MODEL: GARDEN 9 ELEVATION: 1
BEDROOMS: 3
OPTIONS: N/A, ALT 2ND FLOOR (4 BEDROOM)

CITY OF CAMBRIDGE BUILDING DIVISION

2490 CORNER LOTS GARDEN 9 (GR) ELEVATION 1 A1 PACKAGE O.REG. 332/12

BARLASSINA CONSTRUCTION
CITY OF CAMBRIDGE

GARDEN 9
FLANKAGE ELEVATION 1

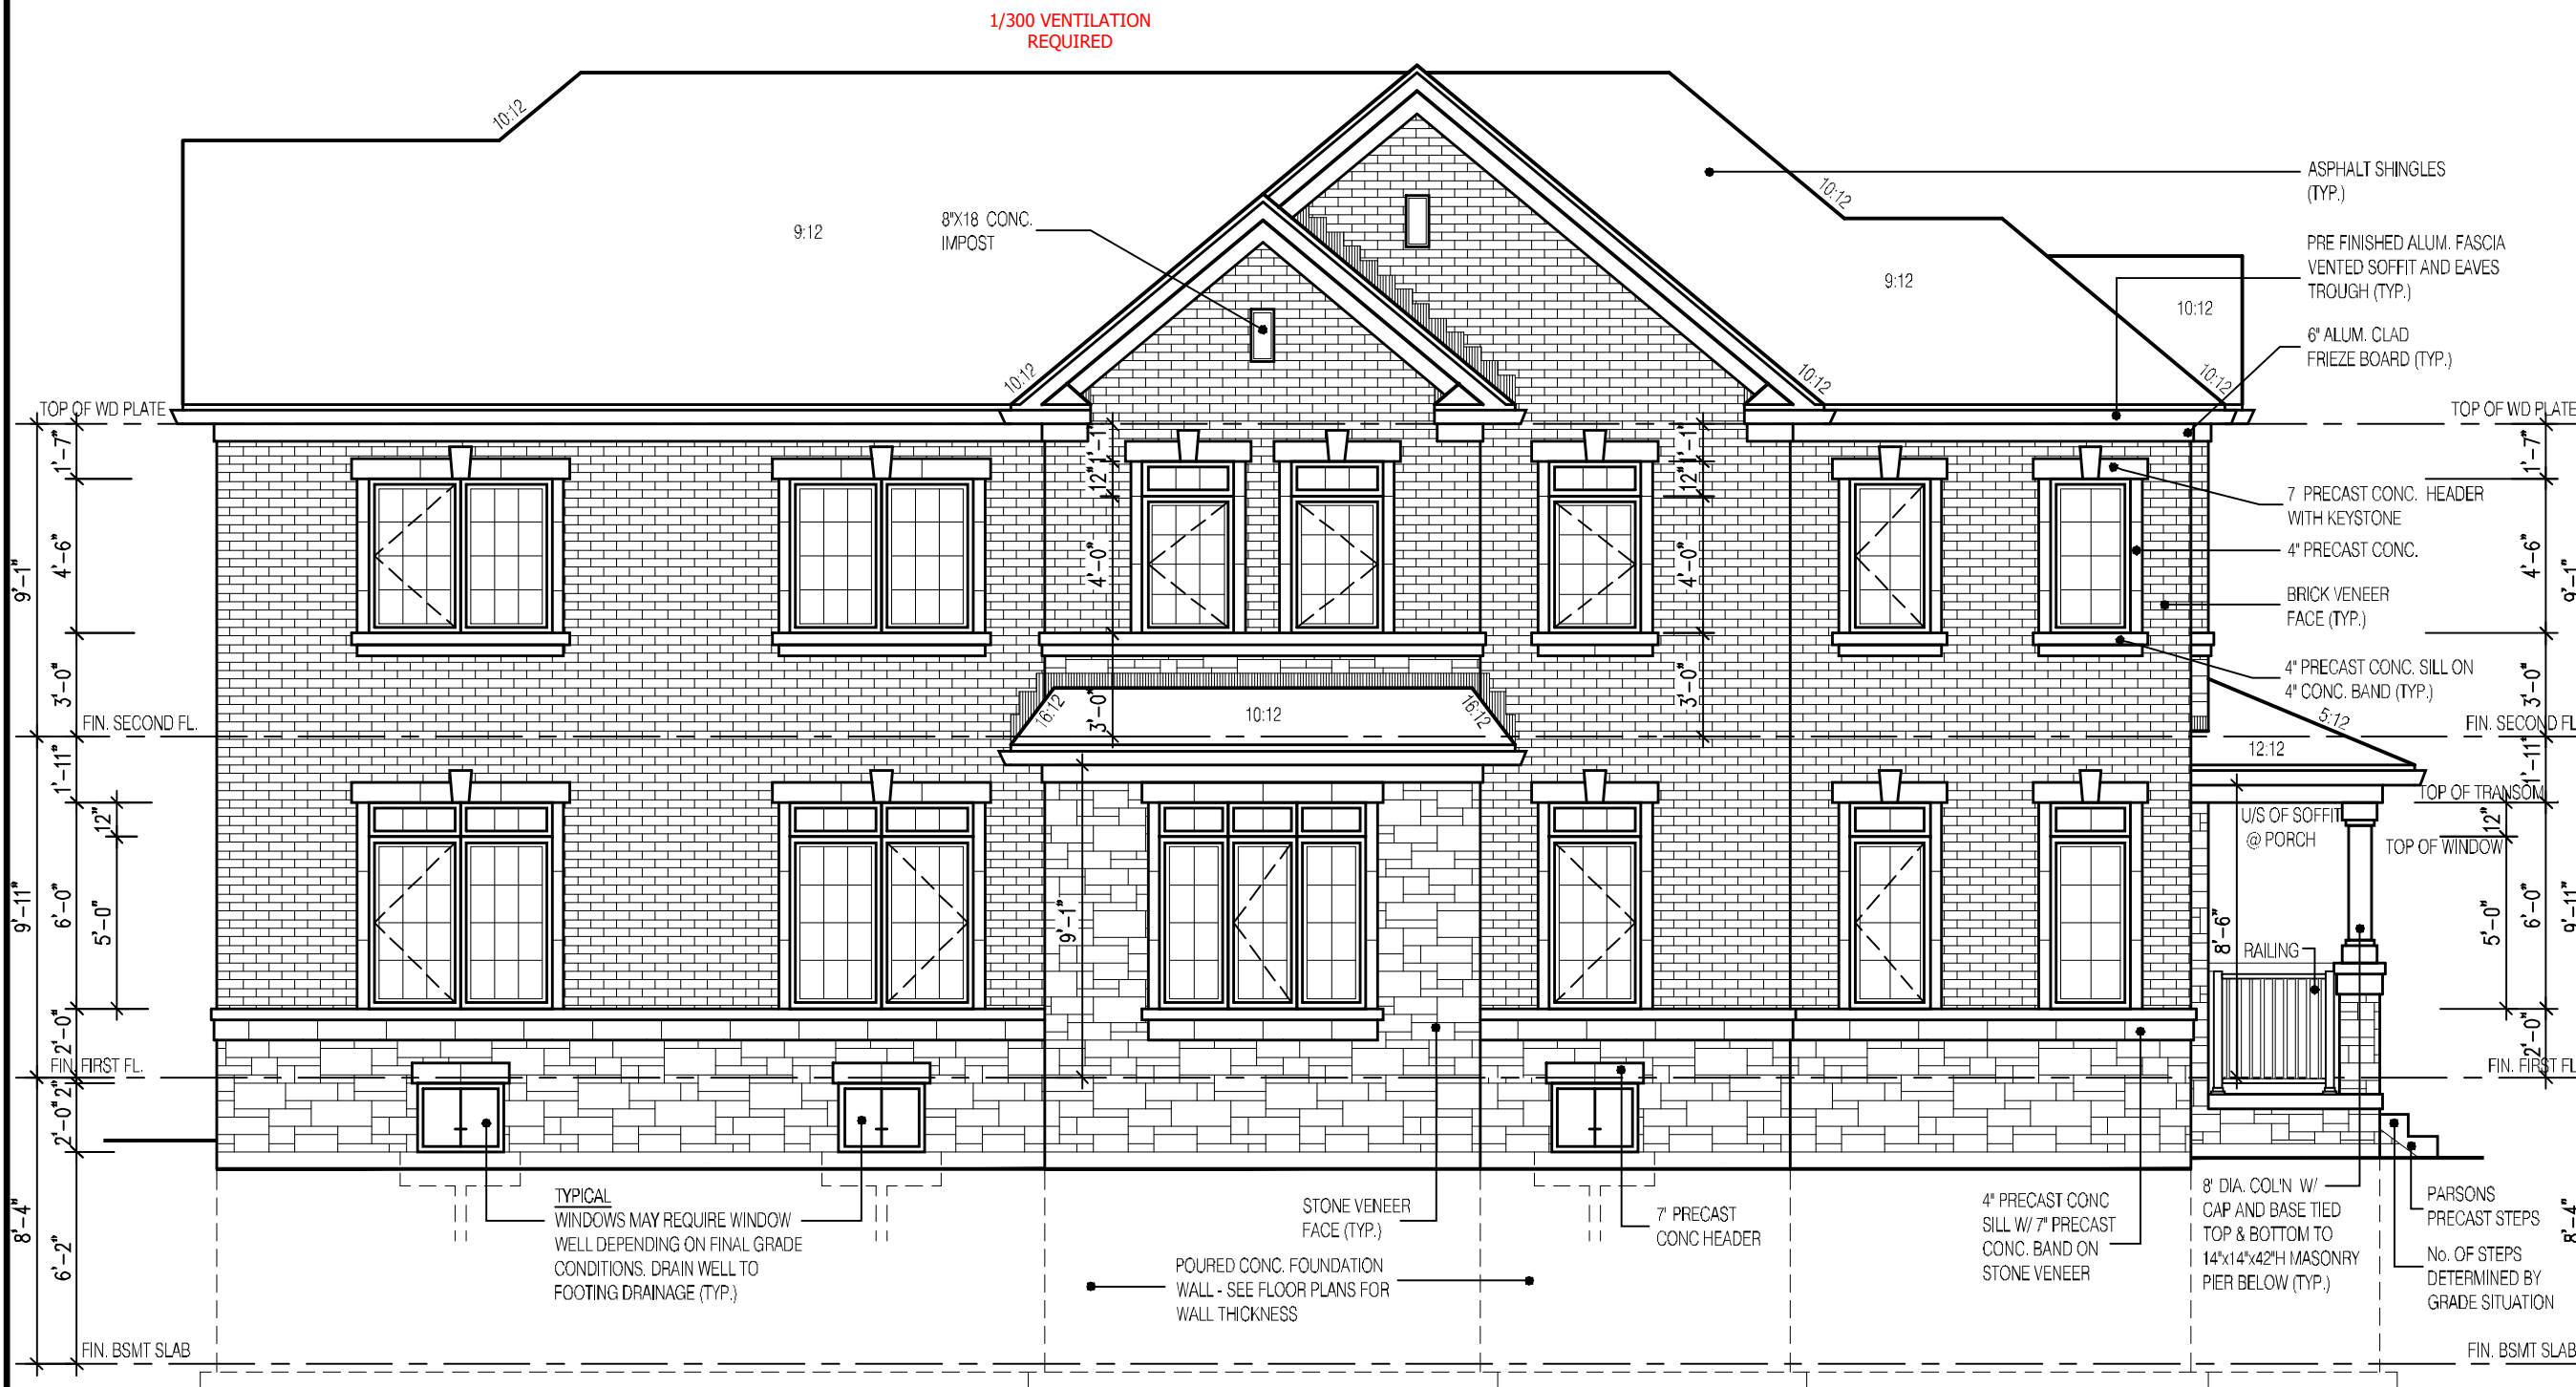
UPO OK, FACES STREET
